Lufttüchtigkeitsanweisung (LTA) Consigne de Navigabilité (CN) Direttive sulla Navigabilità (DN) Airworthiness Directive (AD)		FOCA AD HB-2016-007
Inkraftsetzung Mise en vigueur Entrata in vigore Effective Date	03 October 2016	Pilatus – P3 FOCA TC/TCDS No: None

Subject: **Fuselage – Main Frame 3 – Wing to Fuselage Attachment Bolts – Inspection**

Applicability: Model P3-03 and P3-05 aircraft, all Serial Numbers (S/N).

Drawing No. P3.03-100.57 given in Appendix 1 of this AD.

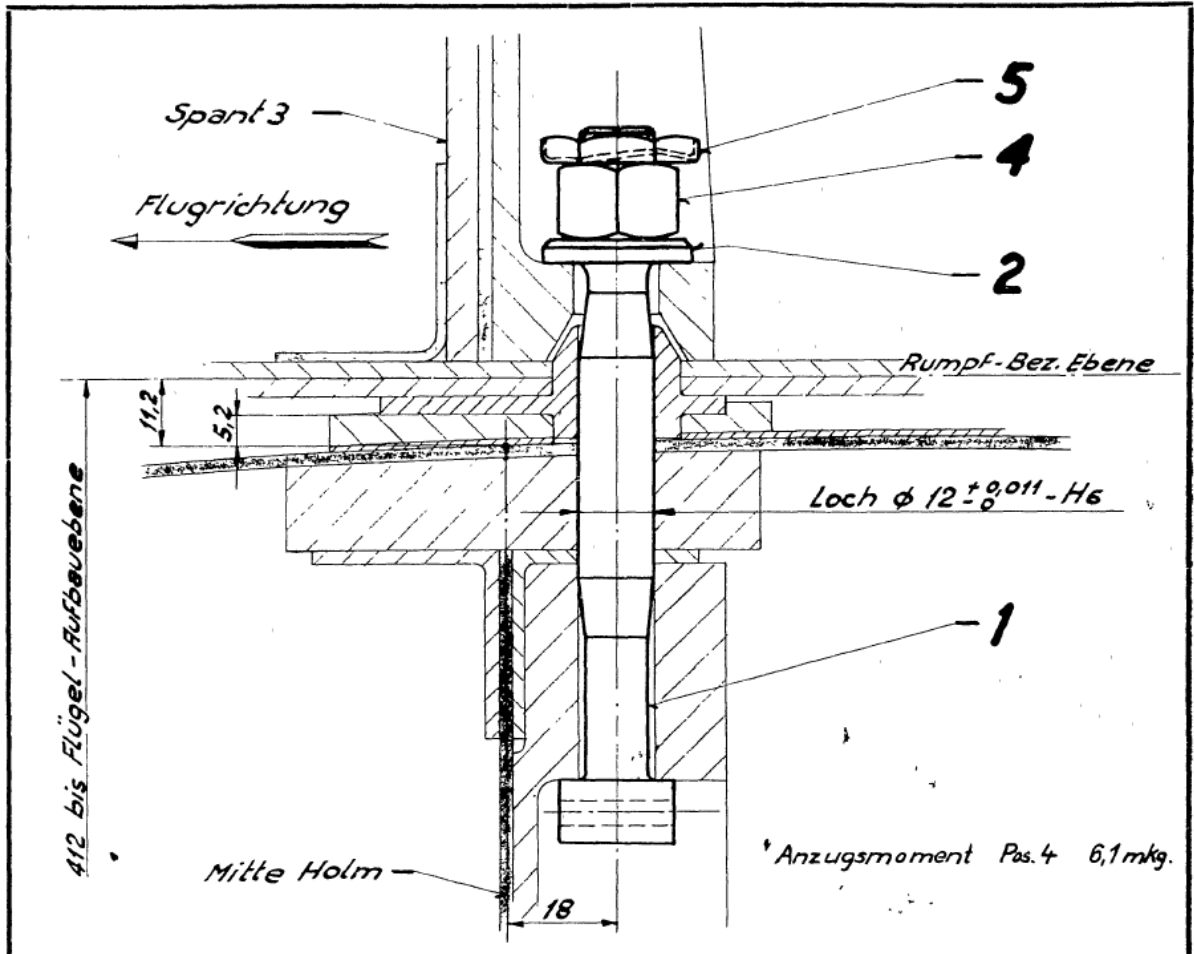
- (1) Within the next 50 Flight Hours (FH) or at the next annual inspection, whichever occurs first after the effective date of this AD, remove the wing to fuselage attachment bolts as described in "Technisches Reglement der Fliegertruppe 56.199d" (the technical description and operating instructions of the Swiss Air Force) and perform a visual inspection for corrosion and a dye penetrant inspection for cracks. No corrosion and/or cracks are permitted.

- (2) If during the inspection by paragraph (1) of this AD any wing to fuselage attachment bolts with corrosion and/or cracks are found, before next flight, replace the wing to fuselage attachment bolts as described in "Technisches Reglement der Fliegertruppe 56.199d" with new bolts. The tightening torque of the new installed or reinstalled bolts is: 60 Nm (6.1 mkg).
